Subject: Site Investigation Report and Remedial Action Plan Review
Approval to Manage Contaminated Soil Under Wis. Admin. Code § NR 718.12 on Site
Innovation Park Lots 2, 3, 4 and Outlot 3, 9480 Watertown Plank Road, Wauwatosa, WI
BRRTS #02-41-588671, FID #341030690

Site Investigation Report and Remedial Action Plan Review

Wis. Admin. Code § NR 718.12 Approval

FIGURE
2

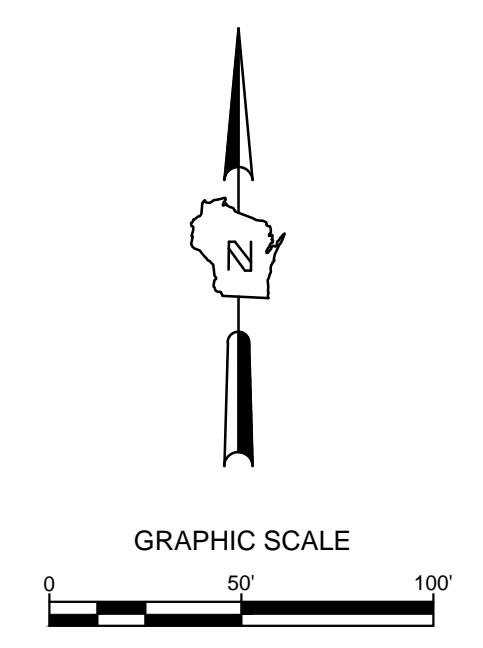
The DNR is currently only responding to the area outlined in red including Lots 2, 3, 4 and Outlot 3, as depicted on Figure 2 submitted as part of the Report. There are documented RCL exceedances in borings on Lot 1 and Outlot 2. Release notifications must be submitted for these lots immediately. These areas, in addition to Outlot 1 and Outlot 4, are currently part of a single property with the same contaminant source (reworked soil/fill) that will require investigation and possibly remediation and/or continuing obligations.

FIGURE 15

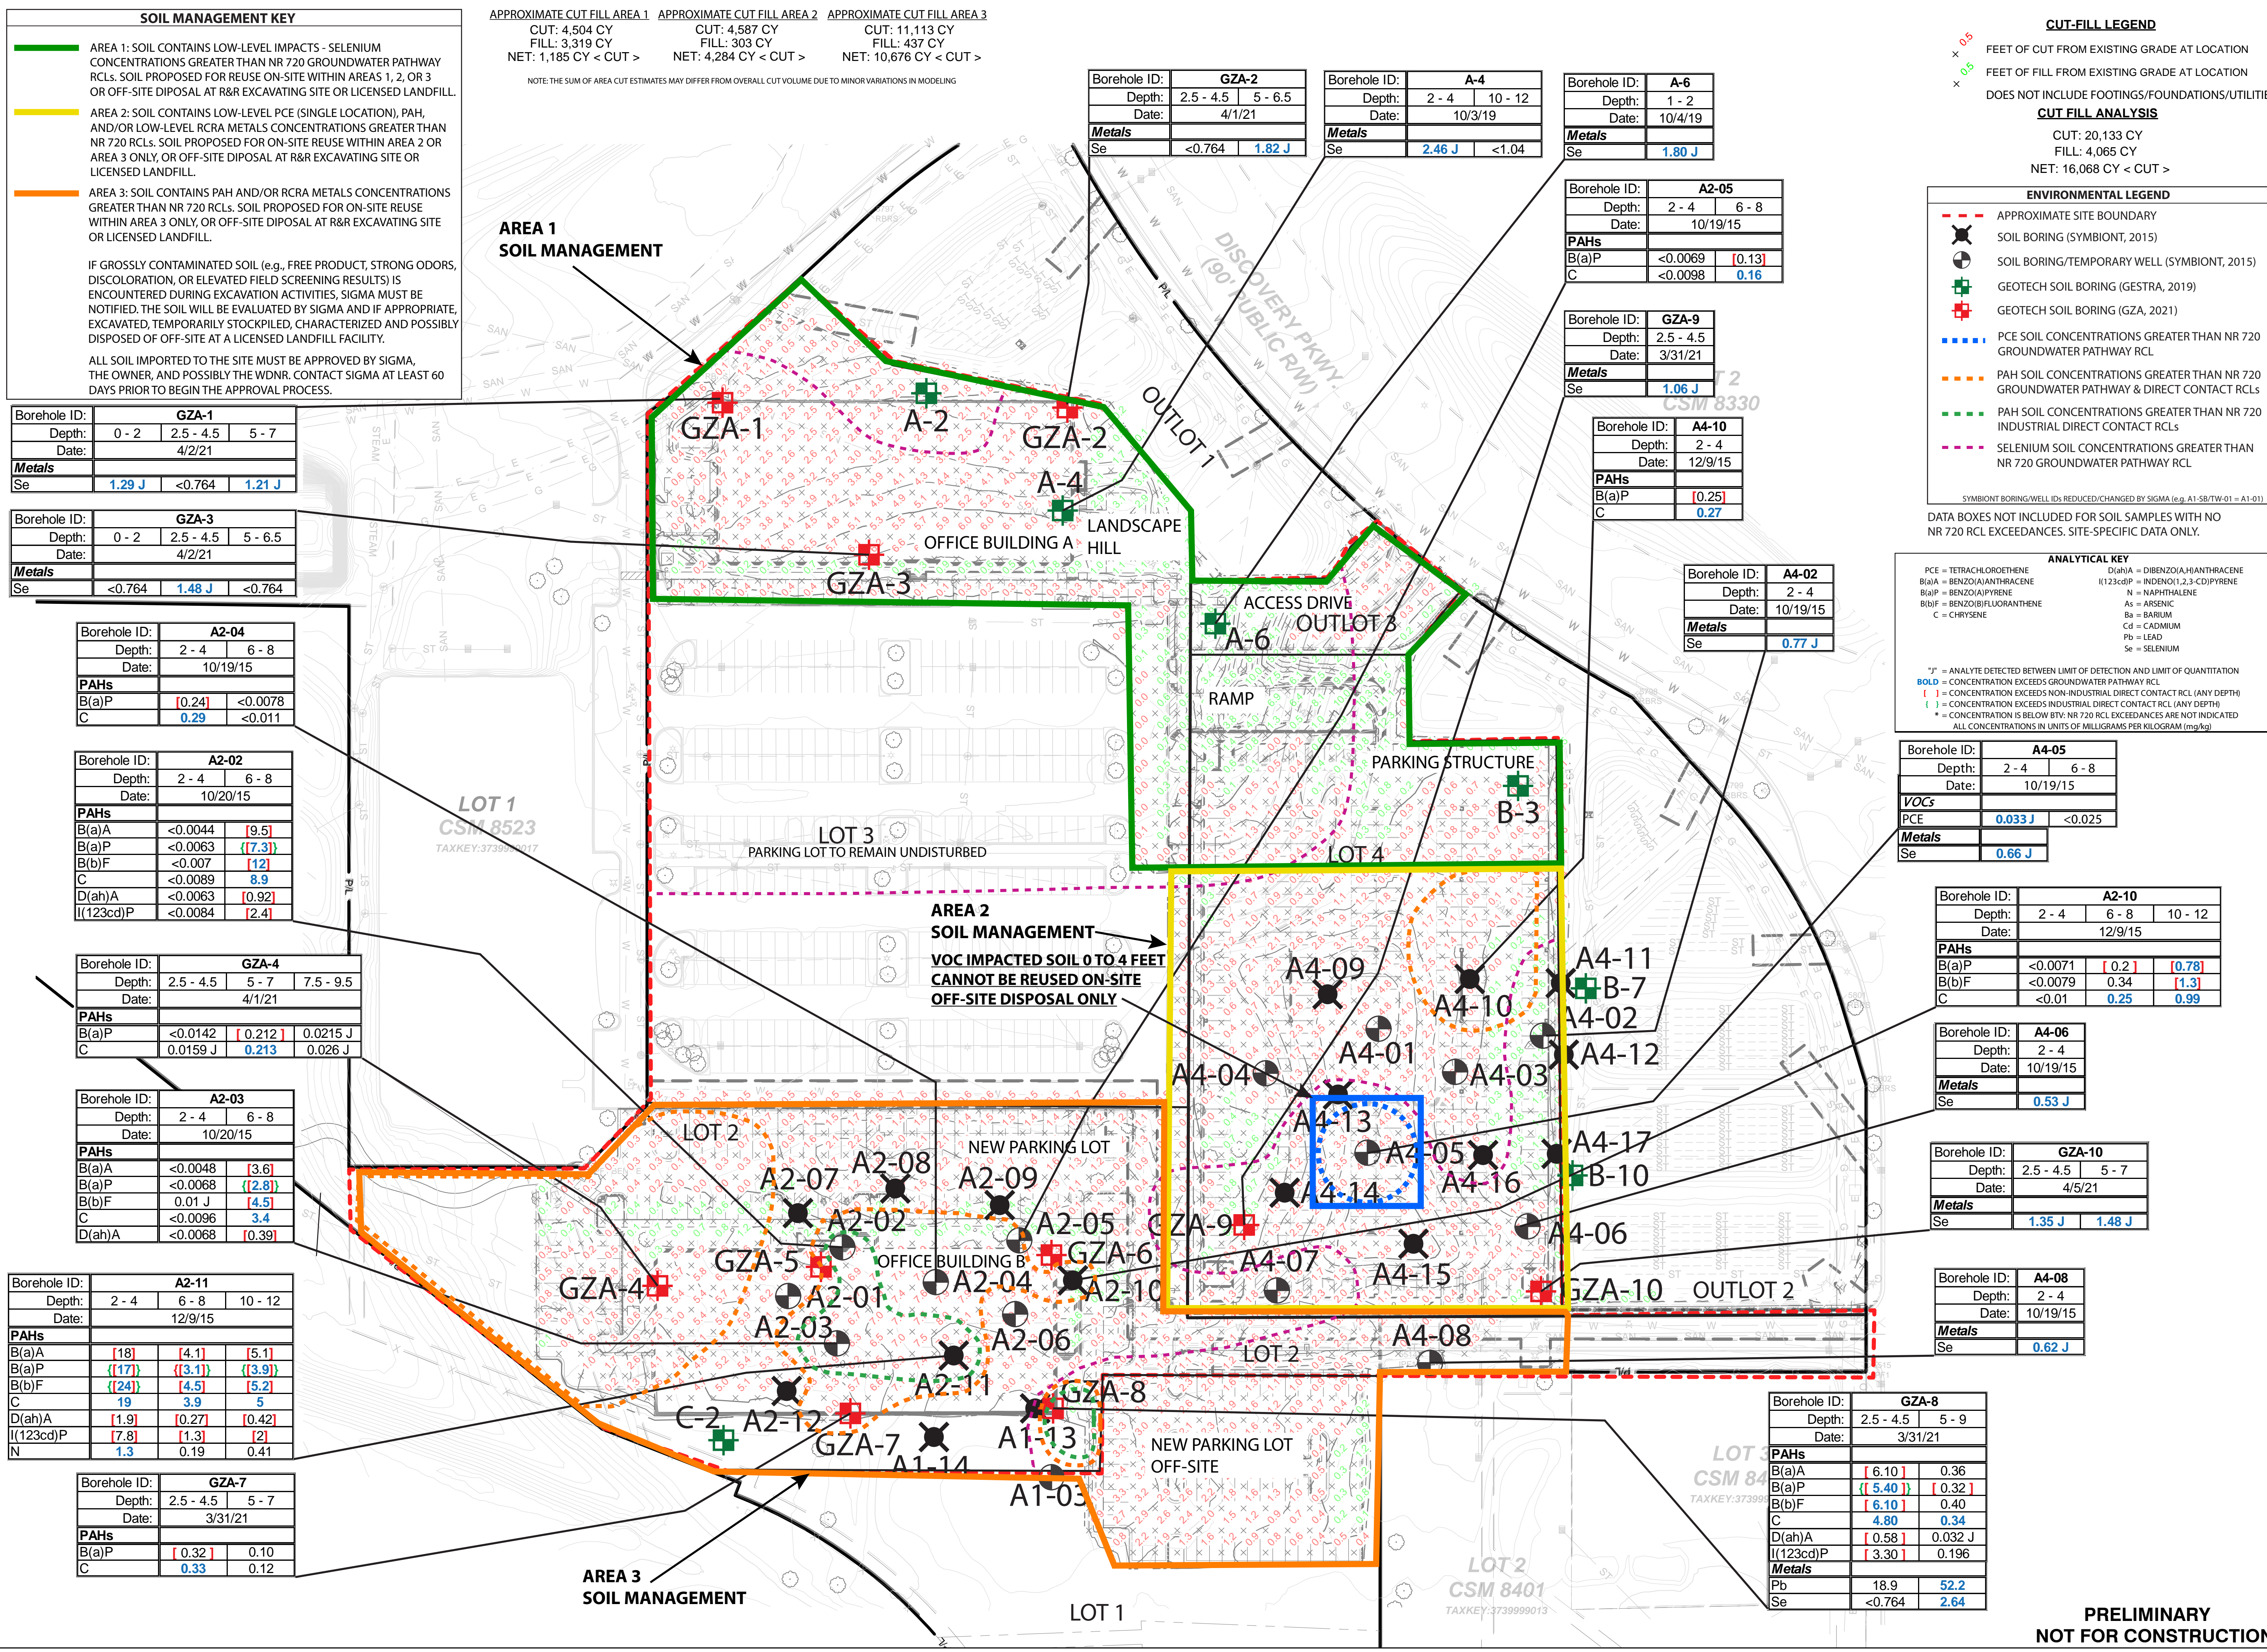
Managing contaminated soil in areas of the site identified on Figure 15 of the Report will meet the locational criteria listed under Wis. Admin. Code § NR 718.12 (1) (c), exception for the following:

- Within 3 feet of the high groundwater level

Grant of exemption to Wis. Admin. Code § NR 718.12 (1) (c) 5

In consideration of the material staying within project limits, that it will be capped and is not expected to impact groundwater, the DNR grants an exemption to the location criteria of Wis. Admin. Code § NR 718.12 (1) (c) 5 and will allow placement of contaminated material in this location.
